Amendments to the Drawings:

The drawing sheet or sheets attached in connection with the above-identified application containing FIGS. 6A-6C, 7, 10-12, and 15A-15E are being presented as sheets to be substituted for the previously submitted drawing sheets. FIGS. 6A-6C, 7, 10-12, and 15A-15E have been amended. Appended to this amendment is an annotated copy of the previous drawing sheet which has been marked to show changes presented in the replacement sheet of the drawing.

FIG.6A

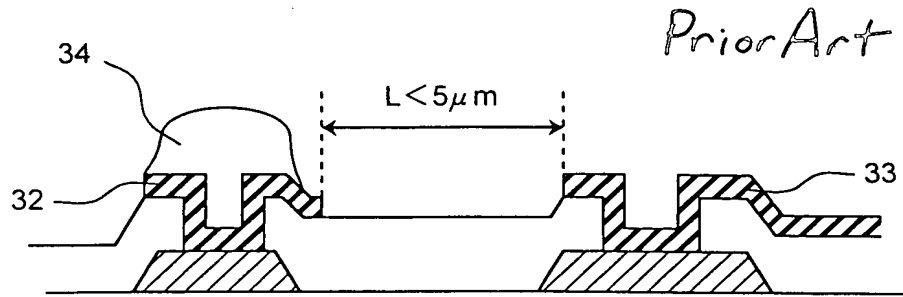
Figures 6A-6C, 10, 11, and 15A-15E have been changed to include the legend "Prior Art."

The PTO has objected to FIGS. 6A-6C, 7, 10-12, and 15A-15E for various minor informalities. The figures have been amended to correct these informalities.

Claims 1 and 13 include the feature “wherein a distance between the first wire and the second wire is more than or equal to 5 μ m.” One with ordinary skill in the art in view of the disclosure would interpret this feature to mean that the distance between the first wire and the second wire as claimed is the narrowest distance between them. Even FIG. 6A and the description given on pages 13-14 of the specification, which was relied upon by the PTO, indicate that the distance between the first wire and the second wire is the narrowest distance between them. As depicted in FIG. 6A, the distance measurement taken from the right-side edge of the first wire to the left-side edge of the second wire, which is the narrowest distance between them, is described as the distance between the first wire and the second wire. This distance is clearly less than 5 μ m since it is so stated in the figure itself where it says $L < 5\mu\text{m}$.

In addition, it is noted that FIG. 6A only indicates one dimension, which is the distance indicated as $L < 5\mu\text{m}$. FIG. 6A is not drawn to scale and provides no other dimensions in which one with ordinary skill in the art could use to even measure the distance from the left-side edge of the first wire to the right-side edge of the second wire. Thus, even the assertion that the distance from the left-side edge of the first wire to the right-side edge of the second wire is 5 μ m or greater, as suggested by the PTO, is incorrect because there is not enough information in FIG. 6A or the specification to make such a determination. “[I]t is

FIG.7

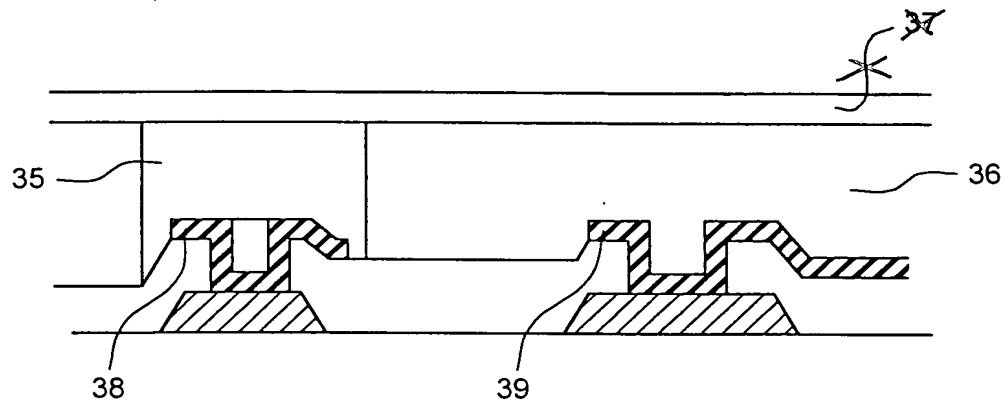
Fig. 7 has been changed to delete the reference numeral "37" from the figure.

FIG.12

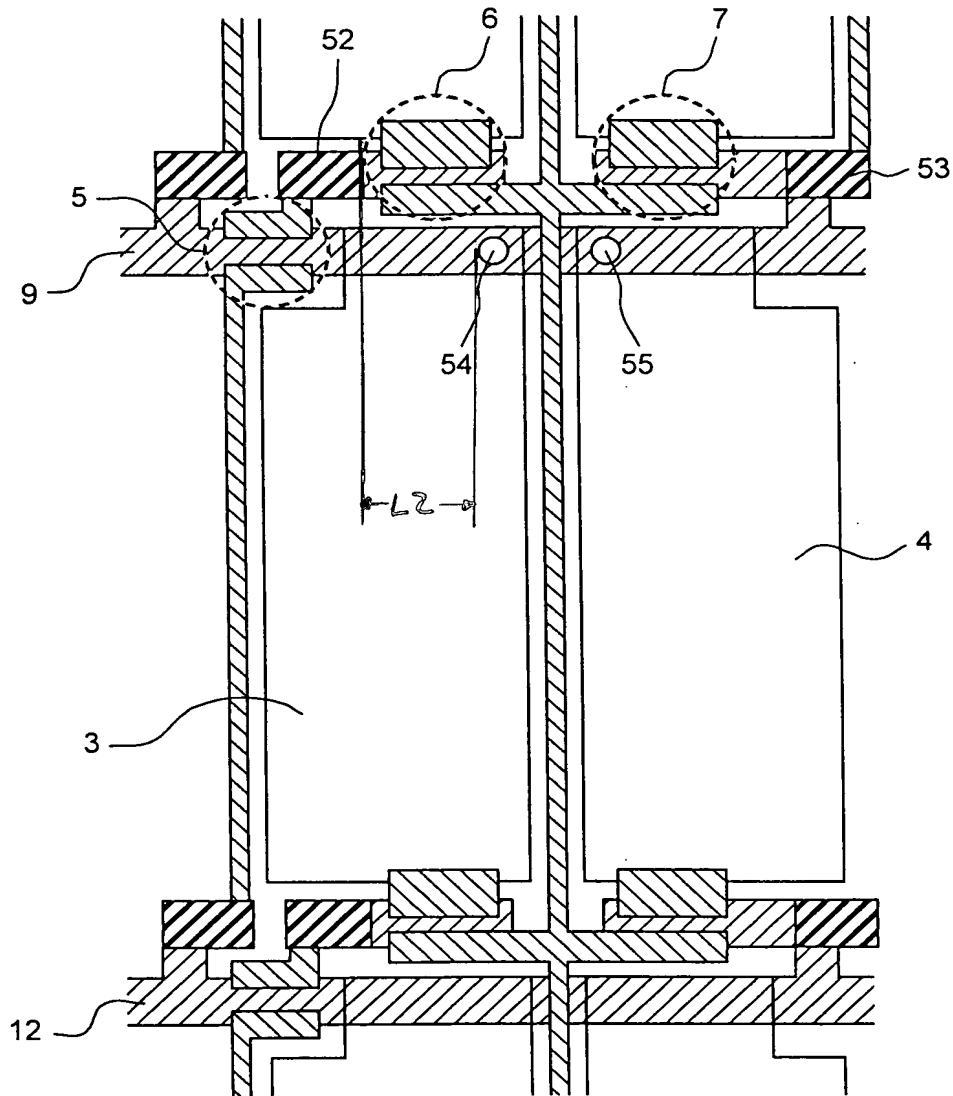
Fig. 12 has been changed to include the character "L2" between the surface wire 52 and the spacer 54, as described in the specification on page 22, lines 15-21.

FIG.15C

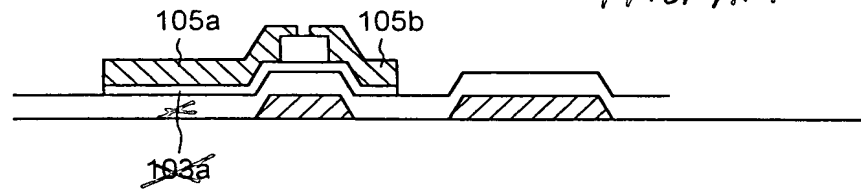
Fig. 15C has been changed to delete the reference numeral "103a" from the figure.
